# ETE Road Map

## Item 6 Site Seismicity

### Preliminary Monitoring Report

Report to the Federal Ministry of Agriculture,  
Forestry, Environment and Water Management  
of Austria

Figure 2.7.7: Detailed topography of the suspected fault scarp of the Hluboká Fault (SE of Hluboká) and a fan adjacent to the scarp. H-1 to H-3 are exploration boreholes. The topographic sections (Section 1 and 2) are shown in Figure 2.7.8. (scanned from Simuek 1995, Fig. 3.5, p. viii).

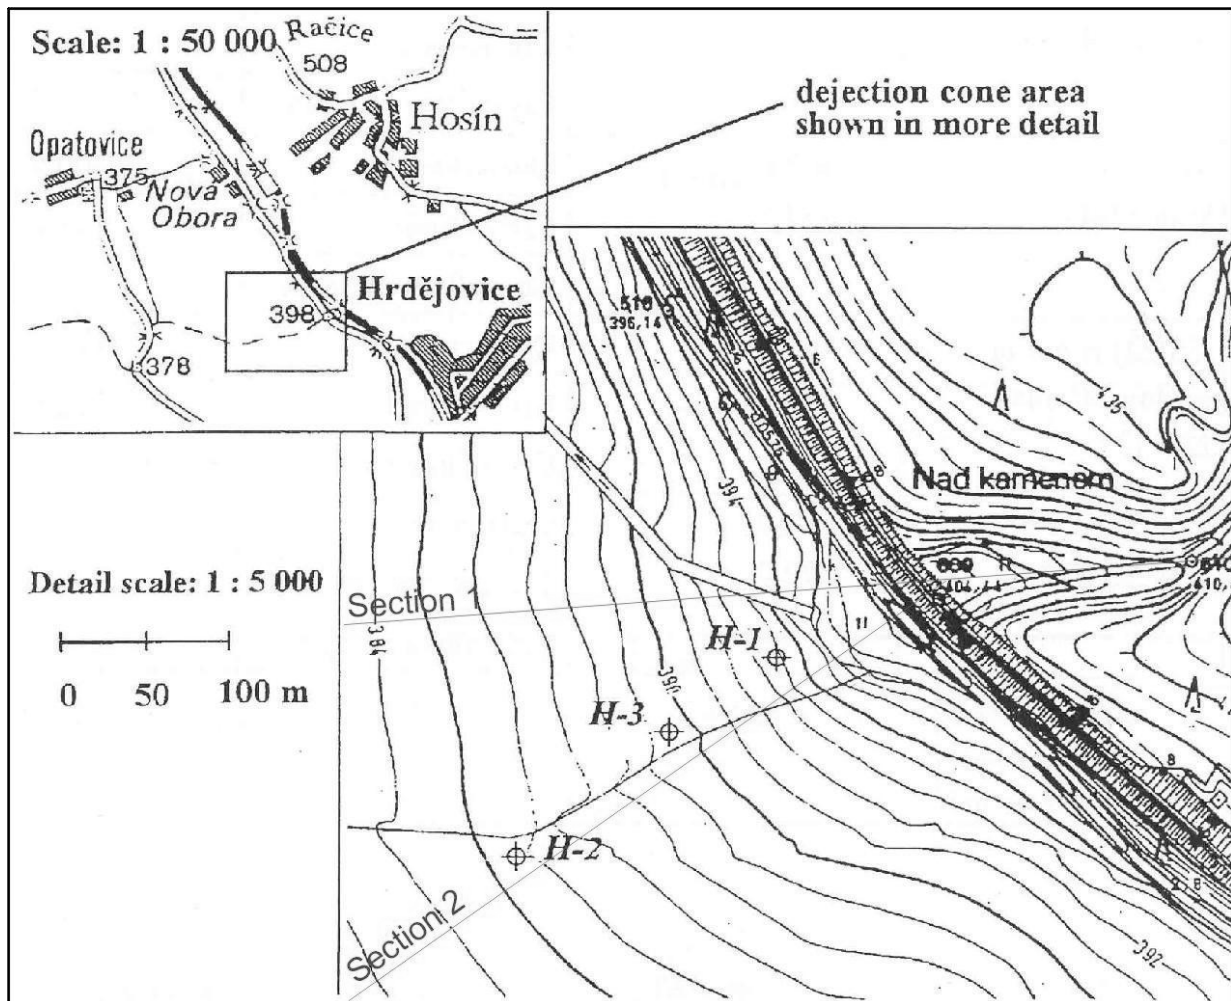
*Hluboká - Hrdějovice.* The most conspicuous scarp occurs SE of Hluboká (Figure 2.7.7). Features pointing to tectonically controlled topography include the rectilinear trend of the scarp and the morphology of a small fan in front of the scarp (Figure 2.7.8); the location S of Hozin “Nad kamenem” is also shown in the Simunek Report, his Figure 3.5). This fan seems to be segmented in comprising slope segments that are relatively linear and that are characterized by abrupt transitions in slope. The relatively steep fanhead with an abrupt down-fan transition to a lower gradient surface could indicate an actively uplifting hinterland of the fan, i.e., active uplift along the Hluboká scarp.

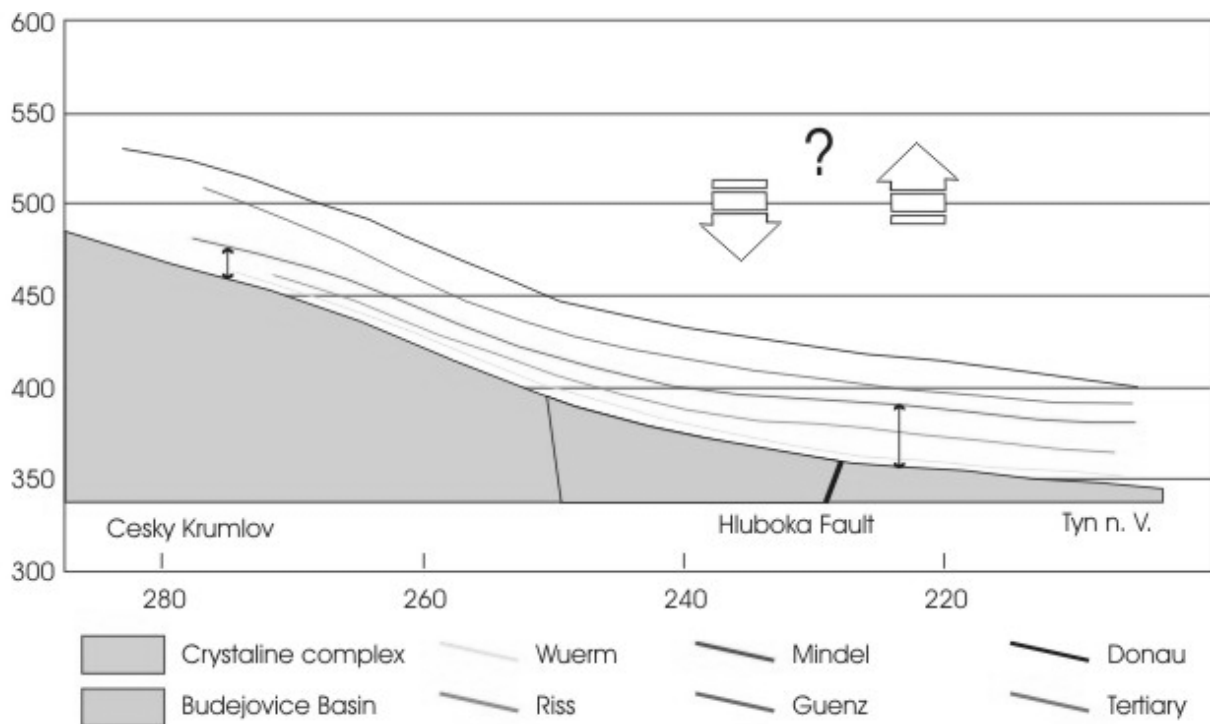
From the geomorphological point of view the drainage pattern of the Budweis Basin is quite peculiar since the Vltava River flows against the Hluboká scarp. The schematic profile along the Vlatva River (Figure 2.7.10; figure 11 in the report by Simunek, 1995) shows an apparent uplift of the Mindel and Riss terrace in the area north of the Budweis Basin. Both terraces show upward convex topography at the crossing of the Hluboká fault, which may be indicative for the relative uplift. In addition, the detailed sections (Fig. 5.1 in the Energoprůzkum report part A, Simunek, 1995) depict a number of river terraces, which are restricted to the area N of the Budweis Basin and which cannot be traced upstream. Both features, the apparent uplift of terraces and the increase of the number of terraces formed, may be related to Quaternary tectonics and the relative uplift of the region N of the Budweis Basin along the Hluboká fault. Both geomorphological features are not addressed in the report. An additional severe weakness of the assessment provided by Energoprůzkum (1995) is the entire lack of appropriate age data for the Quaternary sediments.

The key result of the survey by the Austrian Expert Team is the suggestion that the Hluboká Fault should be investigated in much more detail in order to assess or exclude its seismic potential. The minimum distance between the fault and the NPP is c. 9 km. Additional geological and geophysical exploration should focus on this fault rather than on the other faults within the near-site of the NPP. Investigations, which deem necessary for emending the assessment to current practice, are shortly outlined in Paragraph 5 of this report.

Figure 2.11.1: Design spectra compared to a simplified spectrum from USRG 1.60 /1973 with 0.5% damping

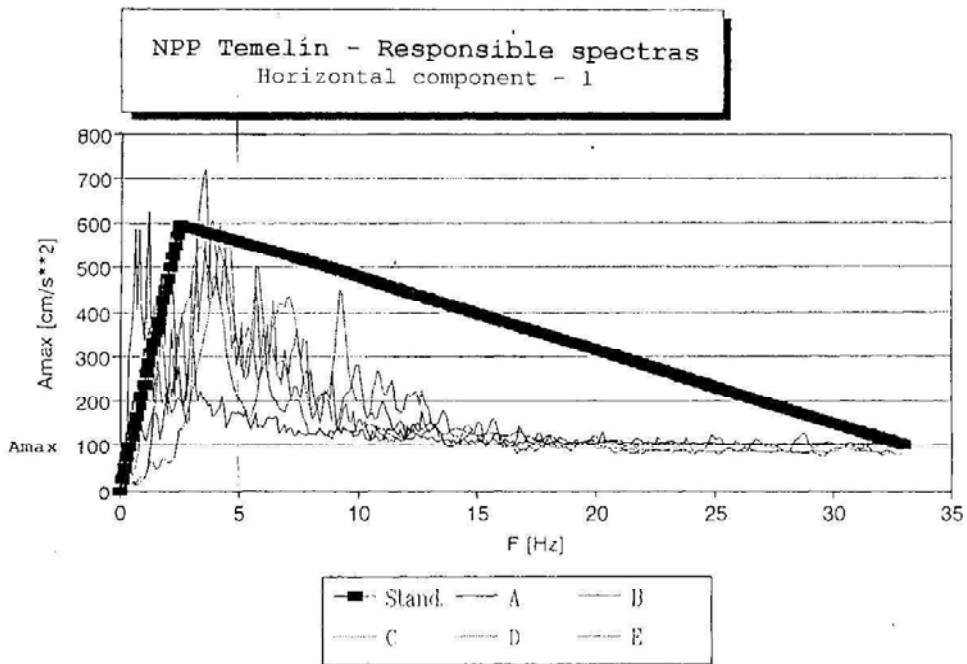
Figur 2.11.1, taken from Šimůnek (1995) compares the design spectra used with a spectrum (cited as standard spectrum) that connects the corner points from USRG 1.60 /1973 with 0.5% damping by straight lines. This spectrum (the cited standard-spectrum) is well above the USRG spectrum at the other frequencies (see also Figure 2.11.2).

The spectra are taken from near distance earthquakes of Intensity  $I_0 = 7$  and  $I_0 = 8$ . Such spectra do not compare with spectra of large earthquakes (Intensity 9) at far distance from the site, even when they have the same intensity on the site, because large earthquakes have longer duration and lower centre-frequency at far distances. So the IAEA request for site specific spectra or comparable spectra seems not to be fulfilled, because the main threat for Temelín site is expected to be inferred from far distance Austrian earthquakes similar to the 1590 Neulengbach earthquake (Gutdeutsch et al., 1987).

Figure 3.11.1: Response Spectra (enveloped curves calculated from selected natural accelerograms and for 5% damping).

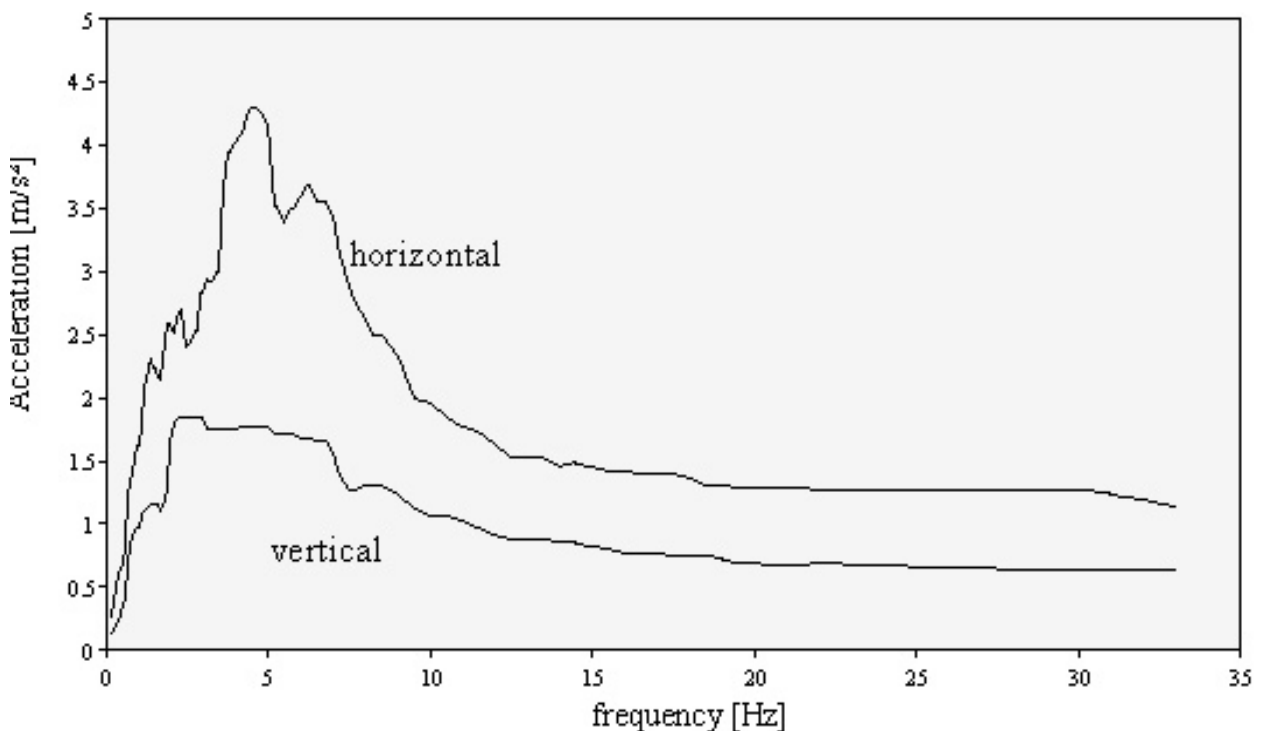
This diagram displays, at low frequencies, rather high values for the horizontal and vertical acceleration, considering that Temelín is generally regarded to be located at a site with low seismicity. Acceleration decreases markedly towards higher frequencies.

Horizontal acceleration reaches a peak value of about  $4.25 \text{ m/s}^2$ , in the frequency range of 2 to 5 Hz. Vertical acceleration is about  $1.6$  to  $1.8 \text{ m/s}^2$  in this range. For the high frequencies, values are about  $1.25 \text{ m/s}^2$  and  $0.6 \text{ m/s}^2$ , respectively.

The spectra for Temelín display generally higher values than the spectra for Konrad and Ahaus, two sites with low seismicity (Figure 2.11.2). Peak horizontal acceleration assumed for Temelín is even considerably higher than the corresponding value for Biblis. The high peak value of the horizontal acceleration in the Temelín spectrum, as well as the unusually rapid decrease towards higher frequencies, clearly requires clarification.
